METROPOLITAN GOVERNMENT OF NASHVILLE AND DAVIDSON COUNTY

STAFF RECOMMENDATION
1812 Boscobel Street
June 19, 2013

Application: New construction—Infill
District: Lockeland Springs-East End Neighborhood Conservation Zoning Overlay
Council District: 06
Map and Parcel Number: 08314032600
Applicant: William Wood, Synergy Development Group
Project Lead: Melissa Baldock, melissa.baldock@nashville.gov

PLOT PLAN

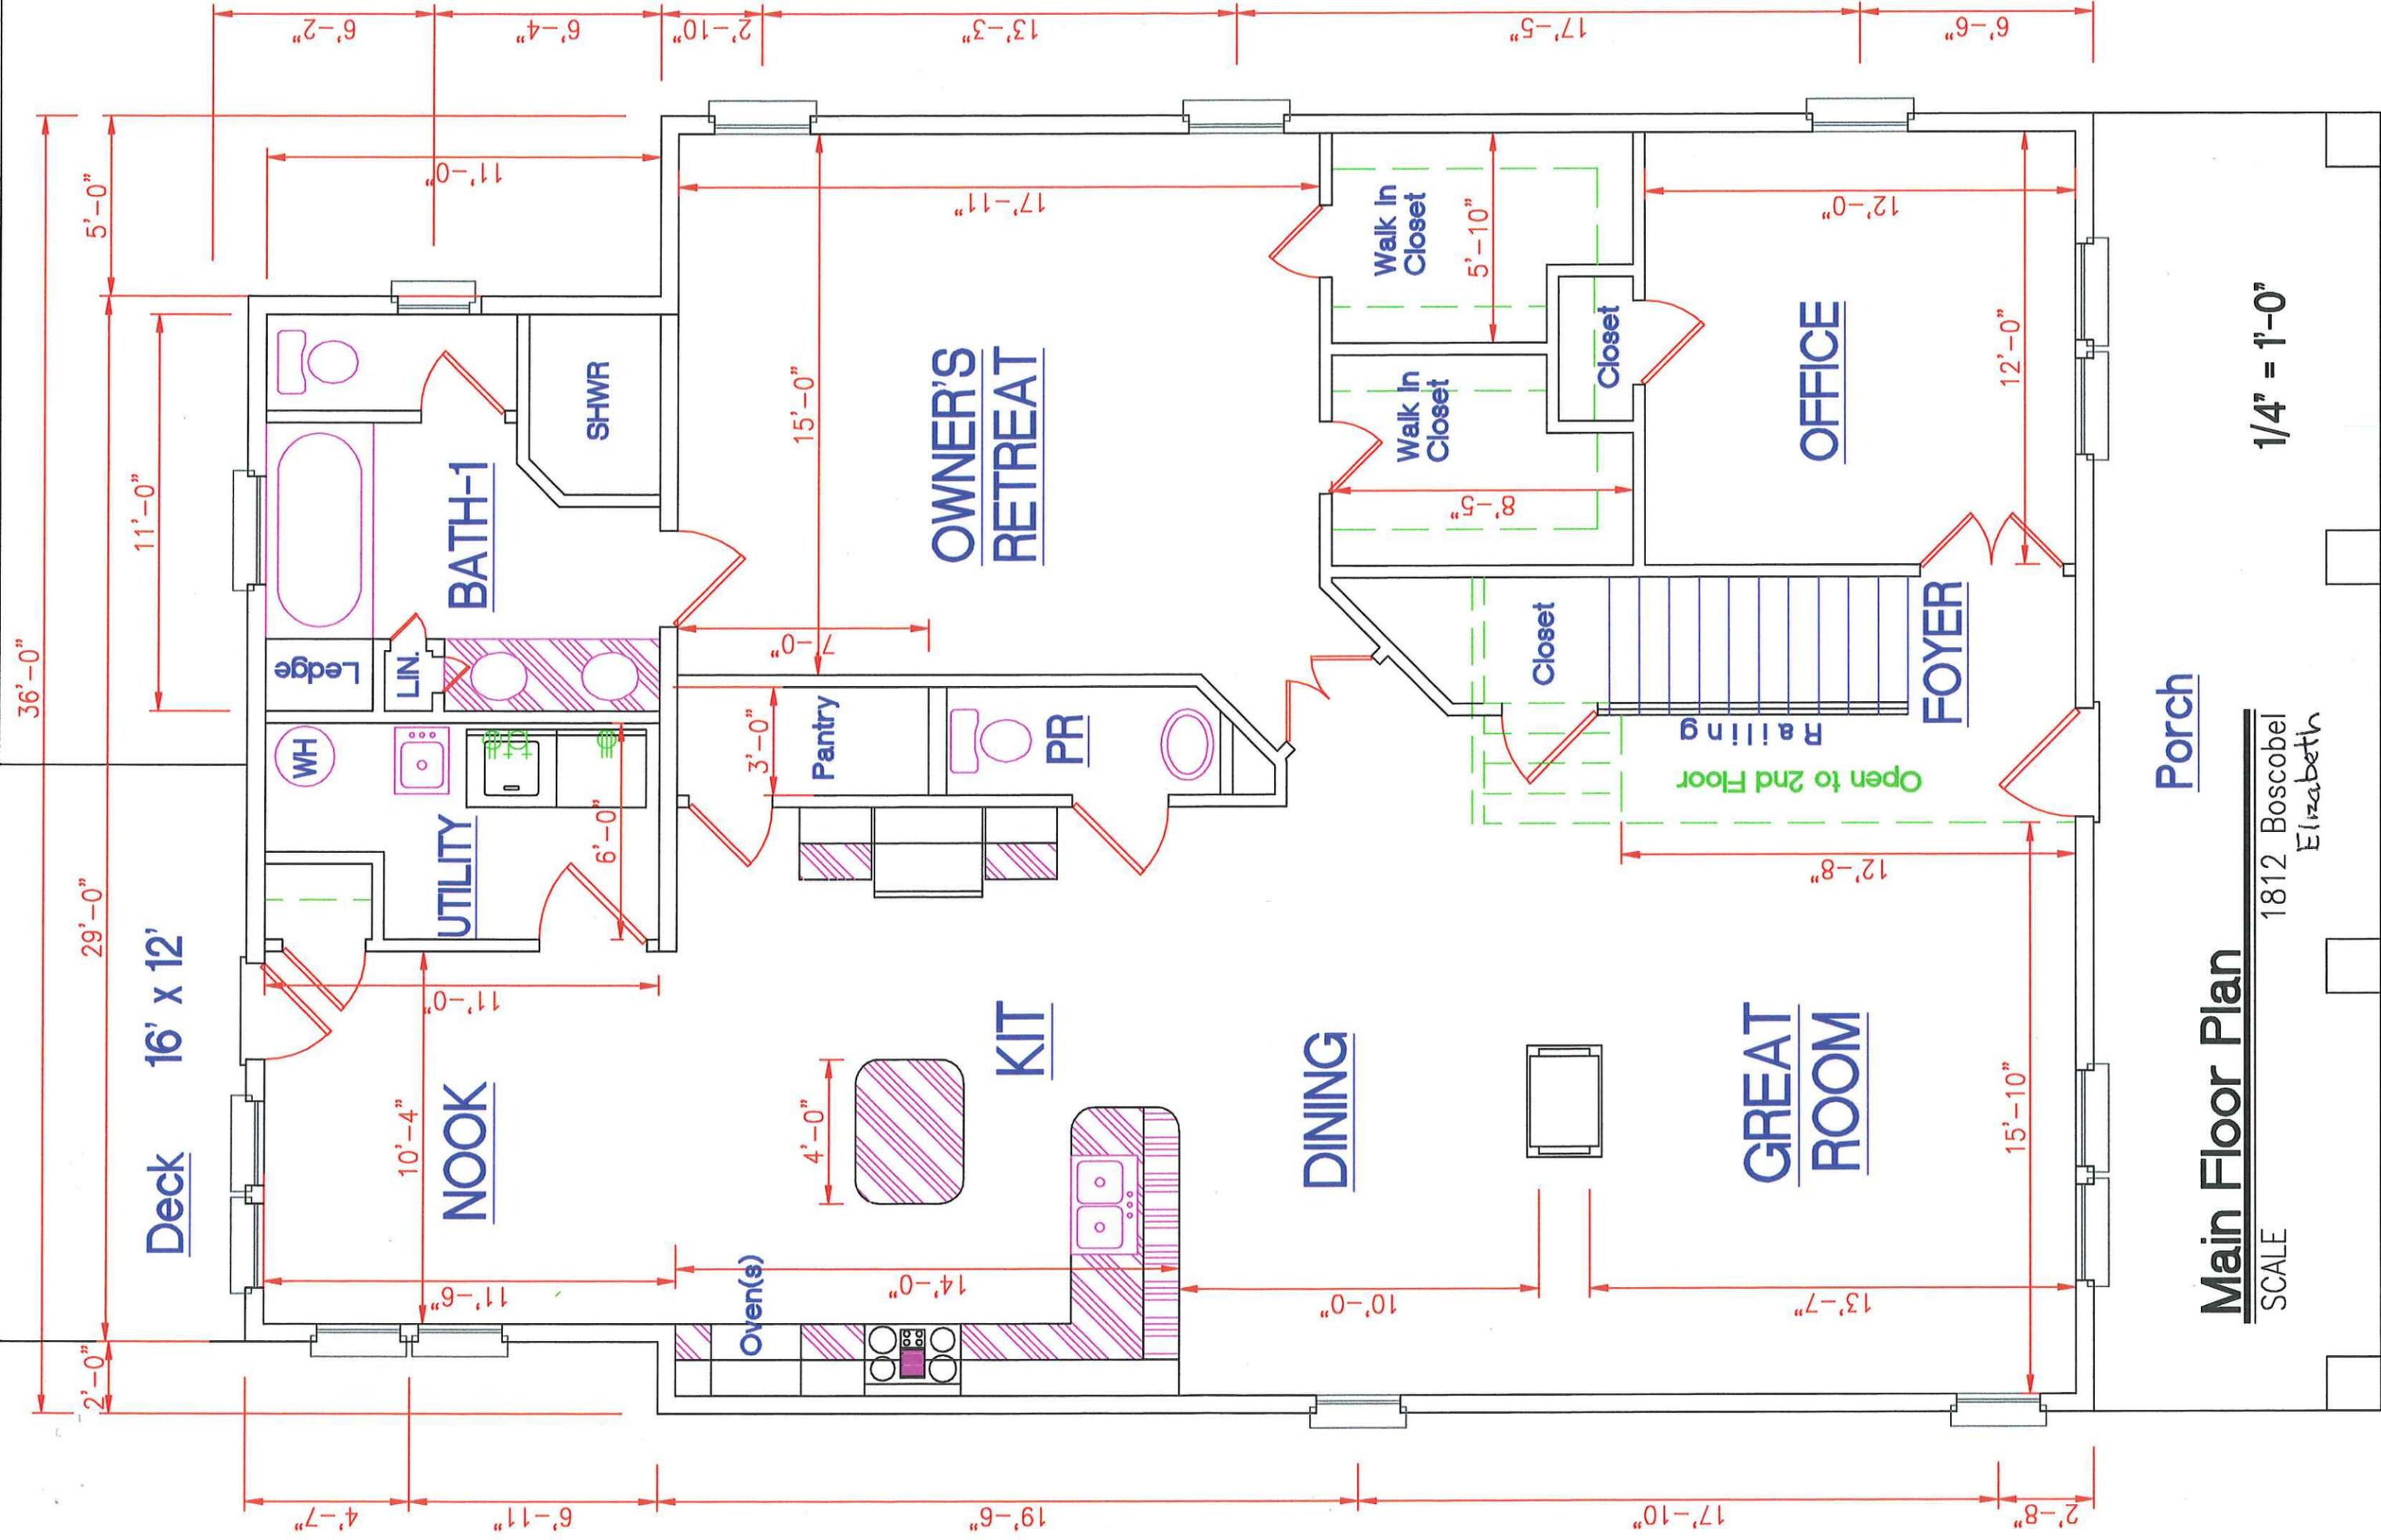
Setback and Rhythm of Spacing: The new infill will be centered on the lot and will meet all base zoning requirements for setbacks. The structure will be located seven feet (7') from each side property line, thereby keeping with the typical rhythm of spacing for the block. The front line of the house's porch will line up with the front line of the porch at 1810 Boscobel and will be pushed slightly forward from the house at 1816 Boscobel Street (Figures 2 & 3). Staff finds the setback and rhythm of spacing of the proposed structure to meet Section II.B.3. of the *Lockeland Springs-East End Neighborhood Conservation Zoning Overlay Handbook and Design Guidelines*.

Appurtenances & Utilities: The site plan does not call out any appurtenances, other than a silt fence which staff assumes will be installed temporarily during construction. Staff asks that the utilities be placed at the rear of the infill or on a side façade, beyond the midpoint of the house. In addition, staff asks to review and approve any permanent appurtenances, including fencing, driveways, lighting, pathways, etc.

Front Elevation

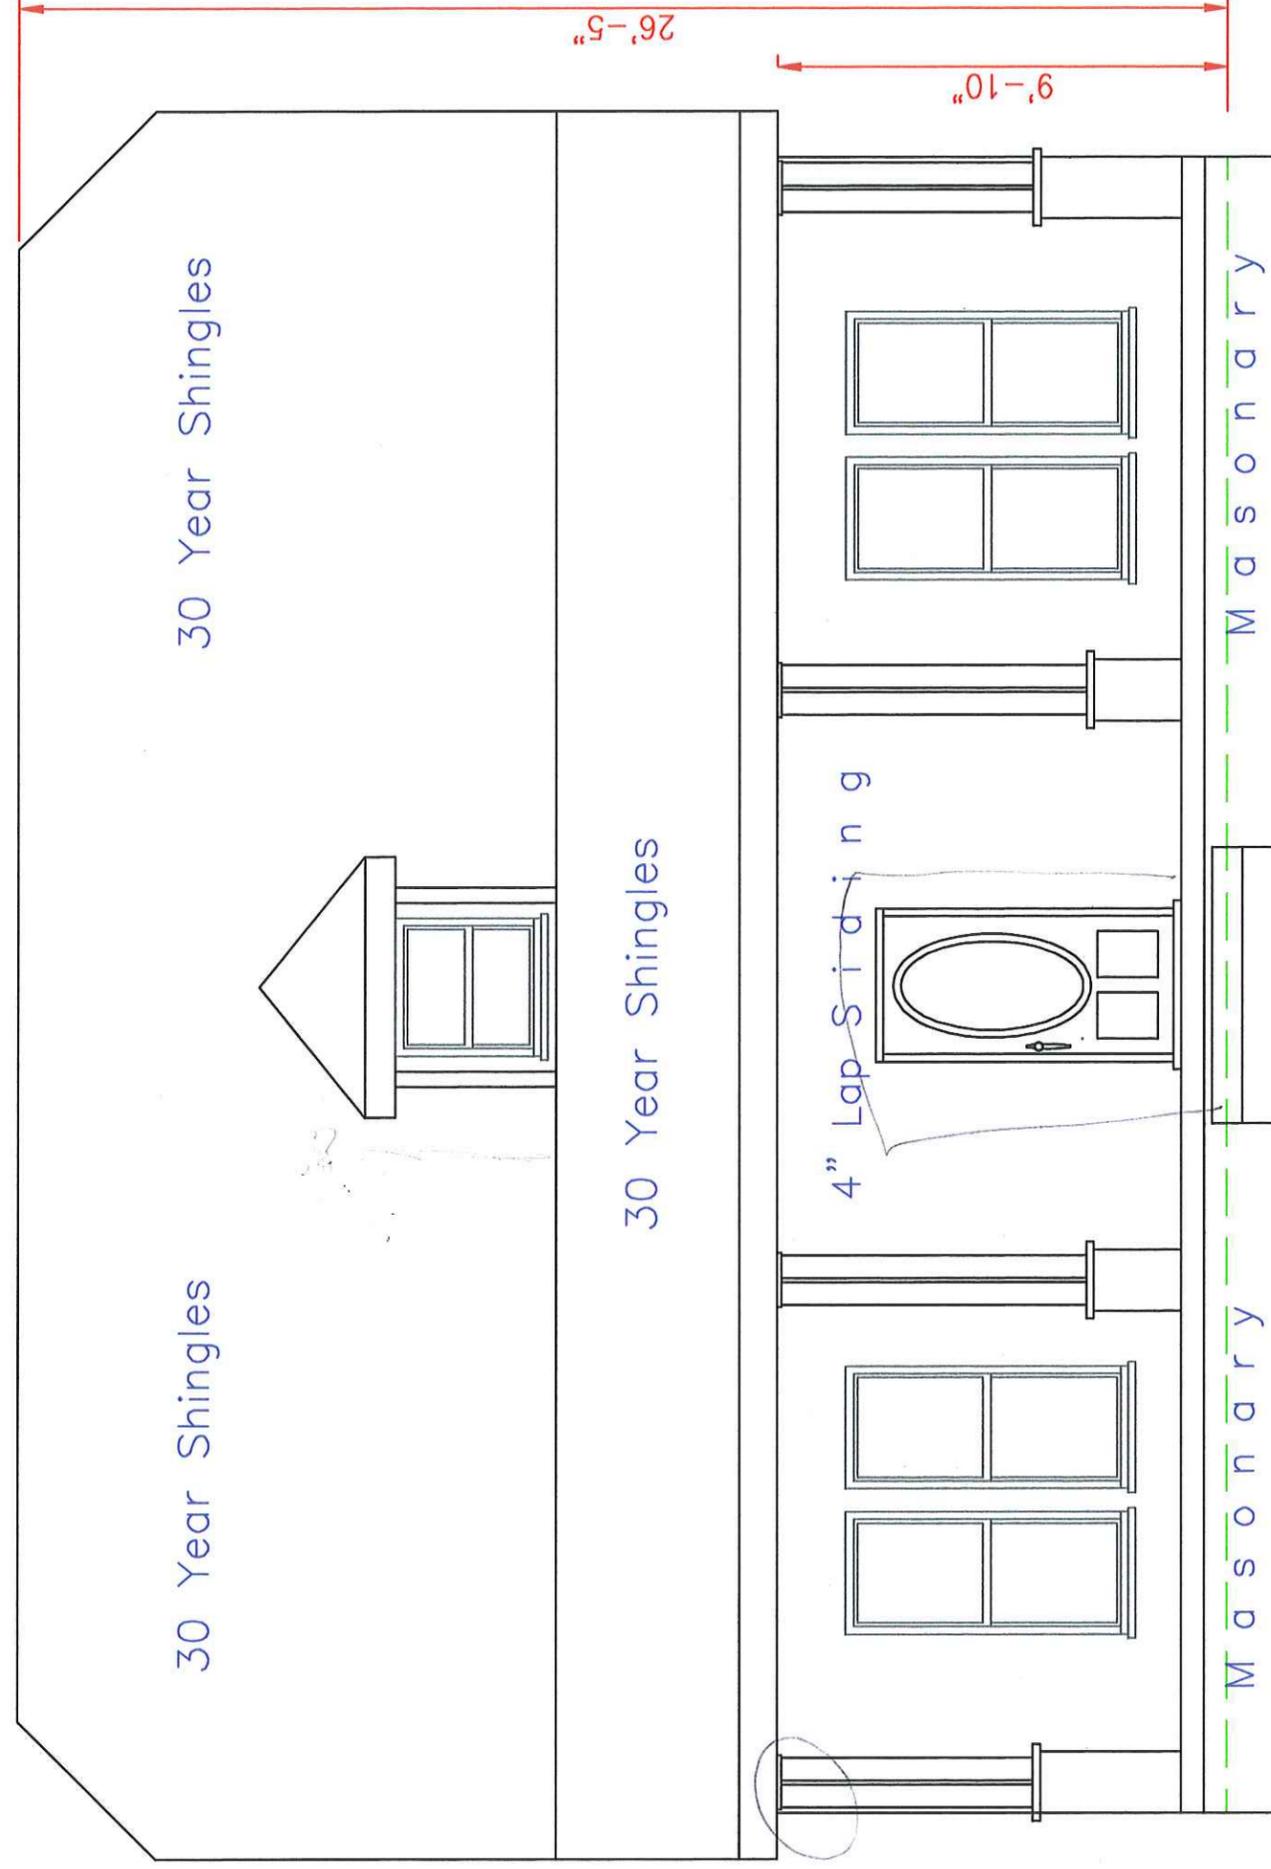
Staff notes that the drawings do not show a door frame around the front door, and asks that one be included. Likewise, the double windows on the front, rear, and left side elevations should have a frame around the pairs and a four to six inch (4"-6") mullion in between the windows. Staff also suggests that adding a band board on the side façades at the change in floor level will help break up the façade. Finally, staff asks that the front porch columns have a more substantial cap.

A central front dormer will have a hipped roof with a slope of 8/12. The dormer is set back more than two feet from the front wall of the house, which is appropriate. The dormer will be approximately four feet, six inches (4'6") wide and six feet, six inches (6'6") tall. Staff asks the applicant to consider enlarging the dormer's width and height so that the proportions of the dormer are more in keeping with other typical central dormers on side gabled houses. The house's roof shapes and pitches are found on historic buildings throughout the district and so meet Section II.B.5. of the *Lockeland Springs-East End Neighborhood Conservation Zoning Overlay Handbook and Design Guidelines*.

1. Staff review all final material choices, including the asphalt shingle color, window and door materials and design, the foundation material, and the materials for the porch columns, bases, and floor;
2. A door frame on the front façade and a band board on the side facades be included;
3. The front porch columns have more substantial caps;
4. All double window openings have a window frame around the pair and a four to six inch (4"-6") mullion in between the windows;
5. The applicant consider enlarging the front dormer's width and height to better match the scale of typical central dormers in the historic neighborhood.
6. The utilities be placed at the rear of the house, or on a side façade beyond the midpoint of the house.
7. Staff review and approved any appurtenances, including driveways, pathways, fencing, and lighting.

Right Side Elevation

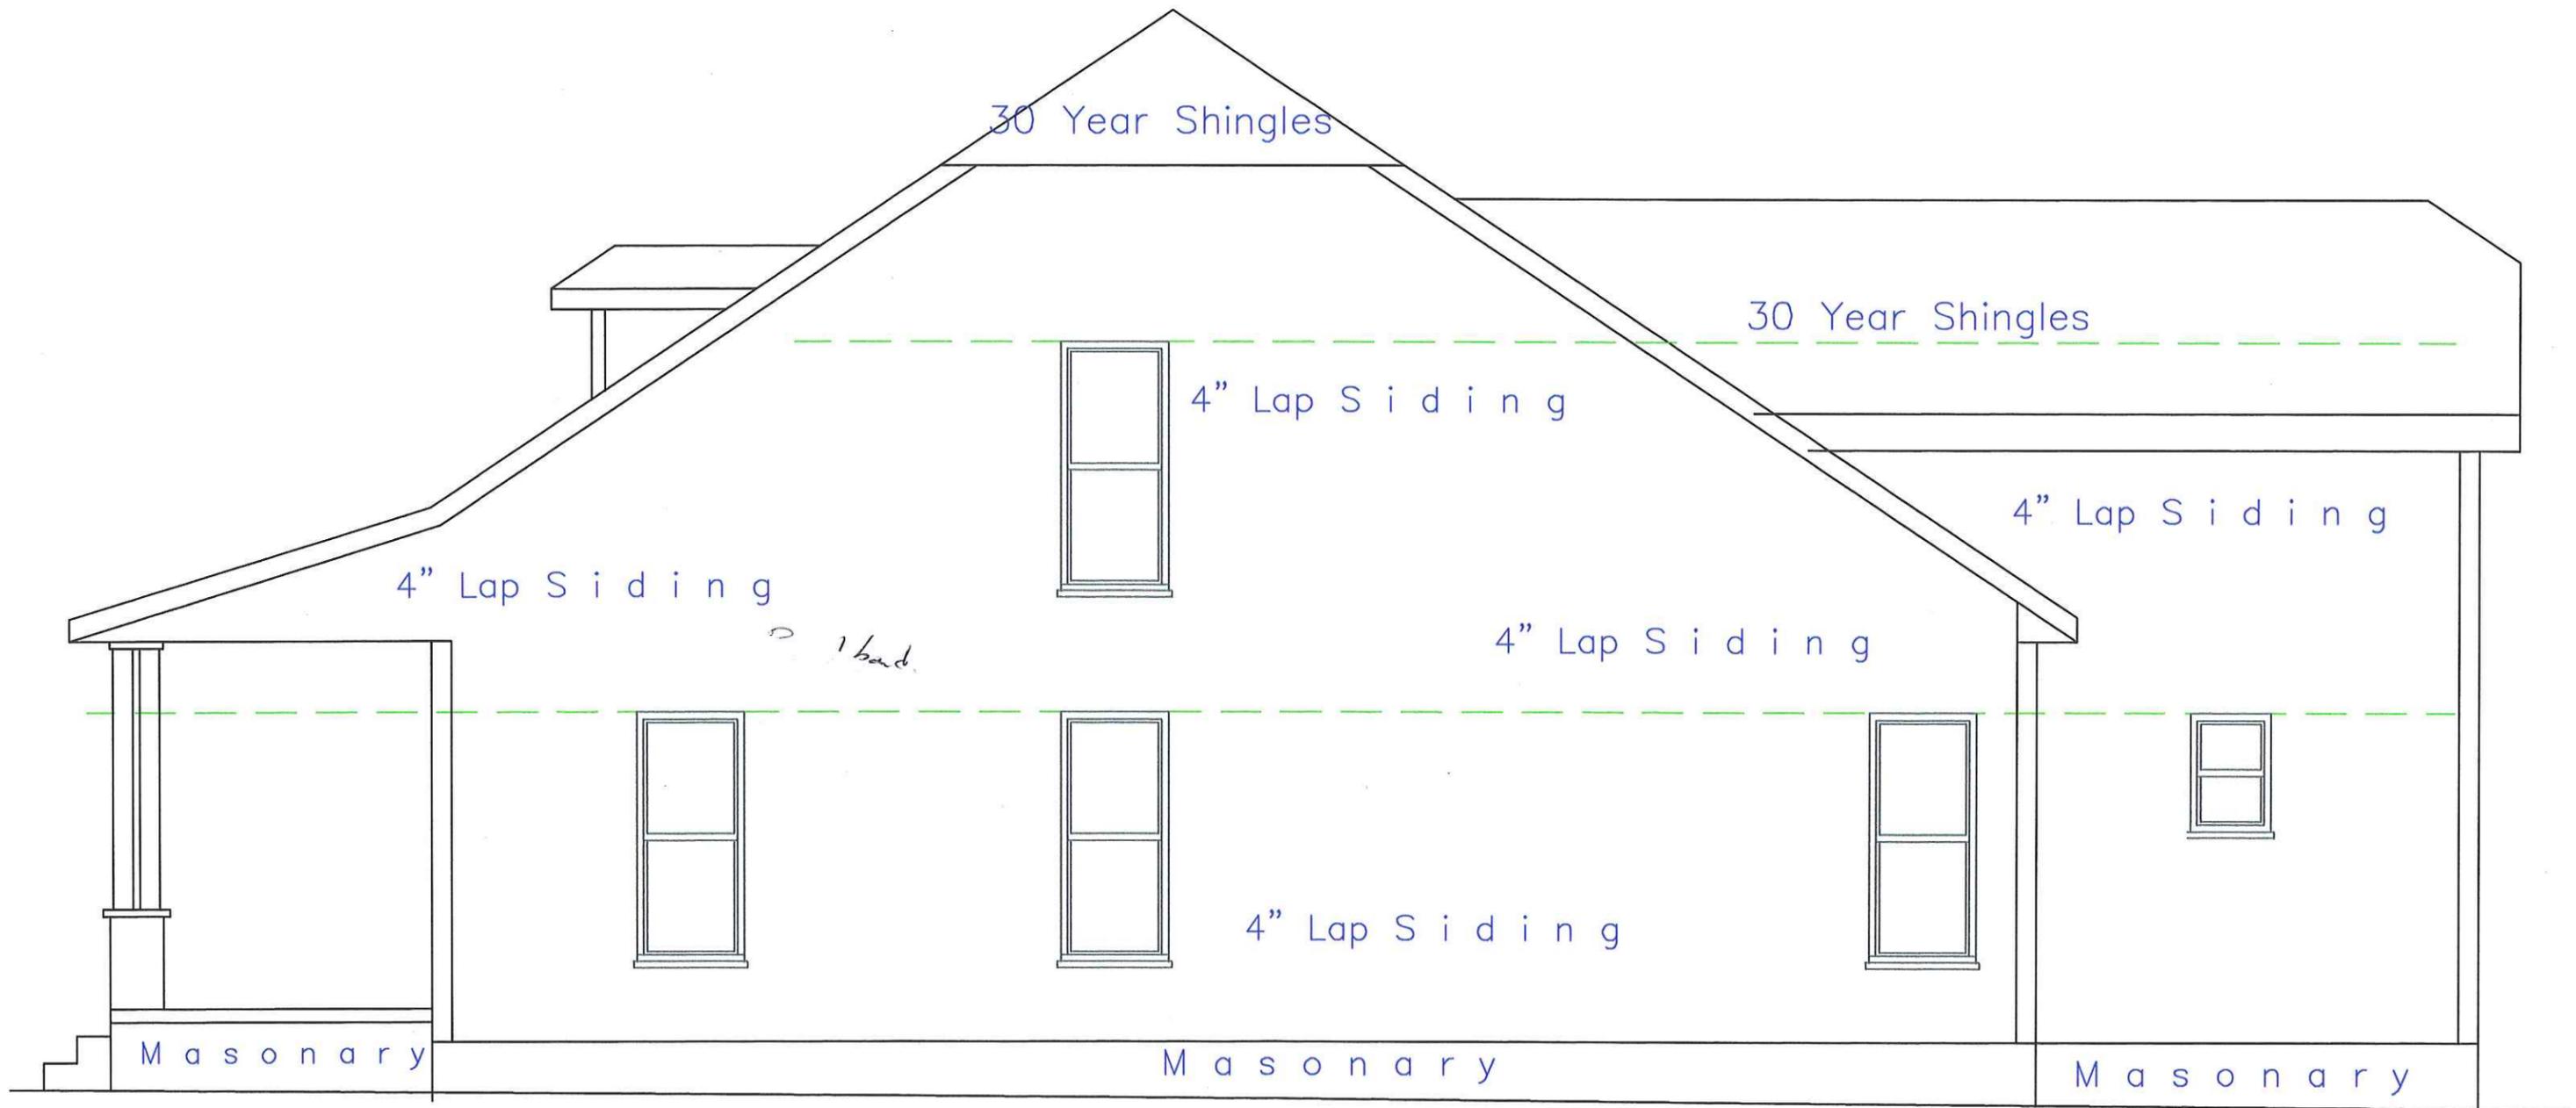
Proportion and Rhythm of Openings: The windows of the proposed structure are approximately twice as tall as they are wide, with the exception of some more utilitarian windows on the side and rear facades. The windows therefore meet the historic ratio of windows in the neighborhood. Both the right and the left facades have wall spaces of approximately seventeen feet (17') without a door or window opening. Staff finds that these expanses are appropriate in this instance because they occur on the side facades, towards the rear of the structure. Staff finds that the window proportions and rhythm of openings meet Section II.B.7. of *Lockeland Springs-East End Neighborhood Conservation Zoning Overlay Handbook and Design Guidelines*.
